SERVICE BULLETIN AMATEUR RADIO

SUBJECT	TH-205 SIGNAL-TO-NOISE RATIO IMPROVEMENT	DATE	10/28/88
---------	--	------	----------

FIGURE 4

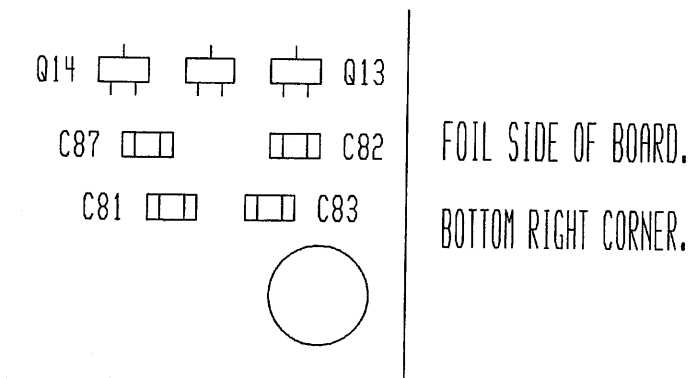
During strong signal reception, the noise level may appear to increase due to unstable action of the active filter in the PLL. To improve the signal-to-noise ratio, install a 390K ohm resistor on the emitter of Q12 (active filter) as described below.

1. Disconnect the battery and antenna.
2. Remove the 7 screws from the back panel of the transceiver (Figure 1).
3. Lift the front panel from the transceiver and lay it to the right side.
4. Disconnect the 2 flex cables and remove the 3 screws from the IF unit (Figure 2).
5. Pull the top panel off and then remove the IF unit.
6. Remove the 8 screws from the RF unit and unplug connector CN2 (Figure 3). Remove the RF unit from the back cover.
7. Locate capacitor C82 on the foil side of the RF unit (Figure 4).
8. Solder the 390K ohm chip resistor directly on top of C82.
9. Assemble the transceiver by reversing steps 1 - 6.

390K OHM CHIP RESISTOR PART # RK73FB2A394J
